## ***City of El Paso – City Plan Commission Staff Report***

**Case No:** SUSU16-00020 West Gate Village  
**Application Type:** Major Combination  
**CPC Hearing Date:** May 19, 2016  
**Staff Planner:** Joaquin Rodriguez, (915) 212-1608  
[rodriguezjx3@elpasotexas.gov](mailto:rodriguezjx3@elpasotexas.gov)  
**Location:** West of Doniphan and North of Country Club Road  
**Acreage:** 9.094  
**Rep District:** 1  
**Existing Use:** Vacant  
**Existing Zoning:** R-3 (Residential)  
**Proposed Zoning:** R-3 (Residential)  
**Nearest Park:** Rio Grande River Trail #1 (.8 Miles)  
**Nearest School:** Lincoln Middle (1.5 miles)  
**Park Fees Required:** \$30,140  
**Impact Fee Area:** N/A  
**Property Owner:** Winton & Associates  
**Applicant:** Winton & Associates  
**Representative:** TRE & Associates

## WEST GATE VILLAGE

# ATTACHMENT 3

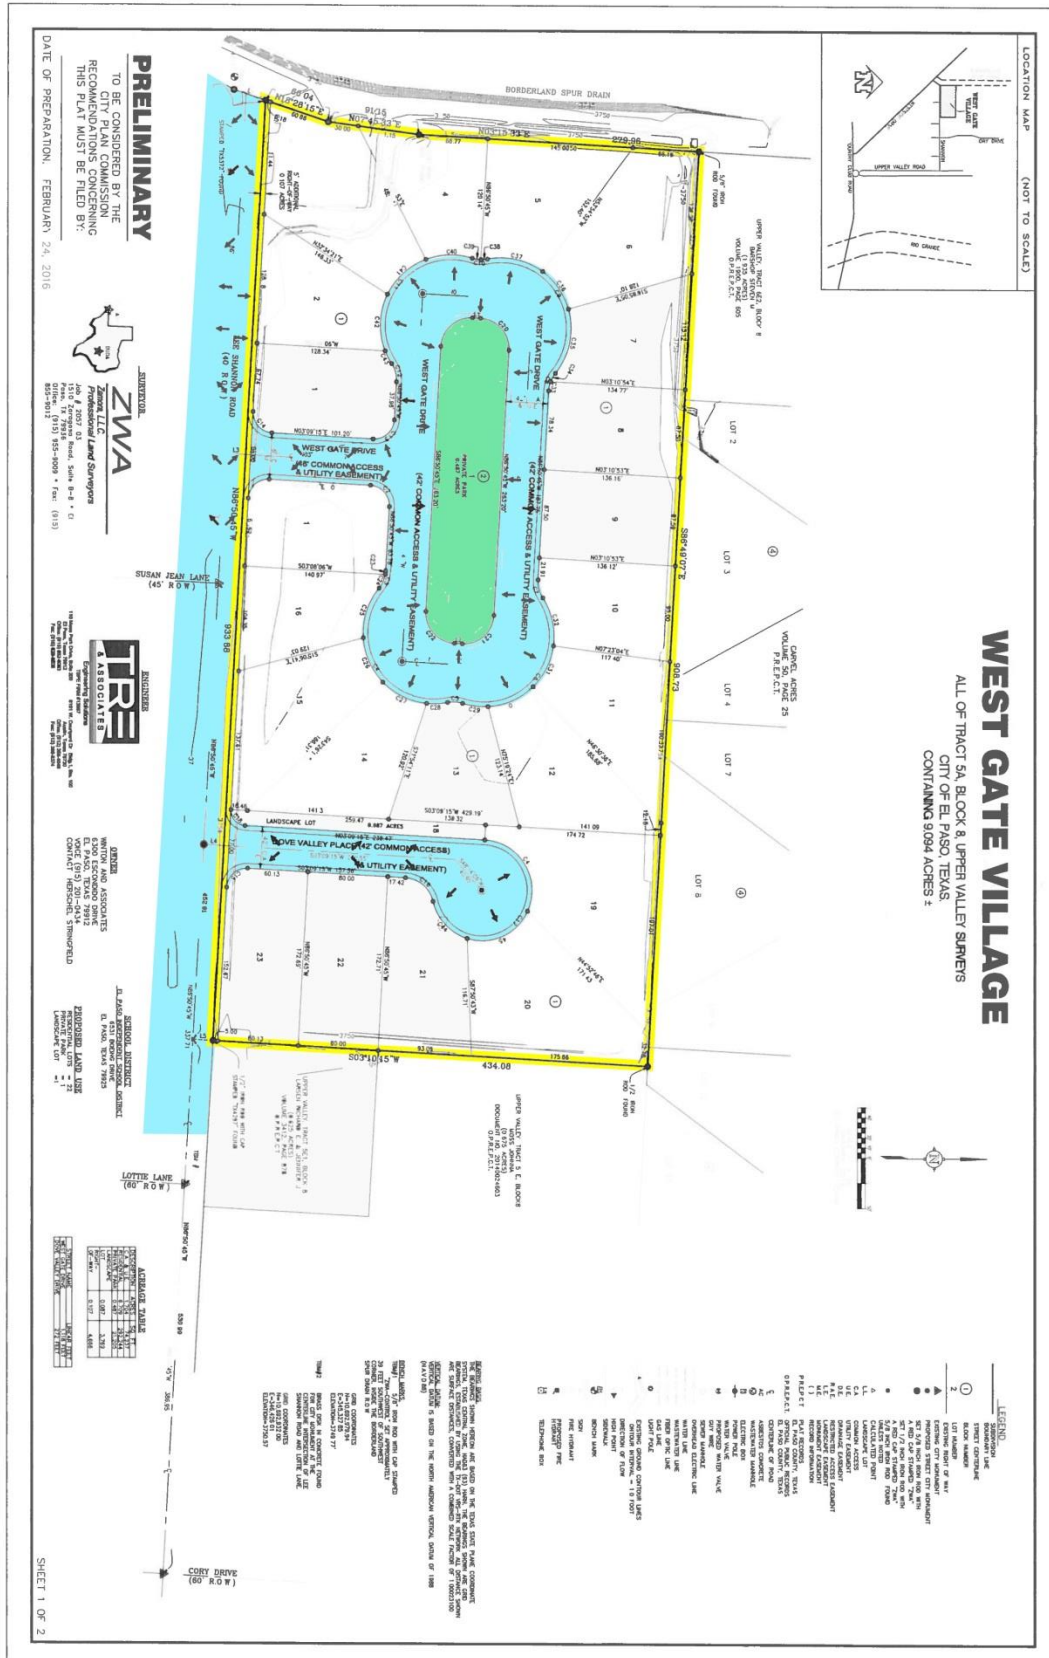
1. Provide contour lines for 200 feet beyond all the boundaries.
2. Provide typical street and lot drainage cross section on preliminary plat.
3. A 6' (foot) high rock wall constructed by Developer will be required abutting Borderland Spur Drain.

4. Label street classifications on typical cross-sections.
5. Minimum West Gate street crown shall be minimum 2.0 percent.
6. Add note to typical street cross sections: Street pavement values shall be determined by CBR report in compliance with Subdivision Improvements Design Standards.

7. Show tie to monument at the SW corner labeled by bearing and distance.
8. Label lot 18 as private on both preliminary and final plats.
9. Include the following on-site ponding requirements as notes on the Final Plat:
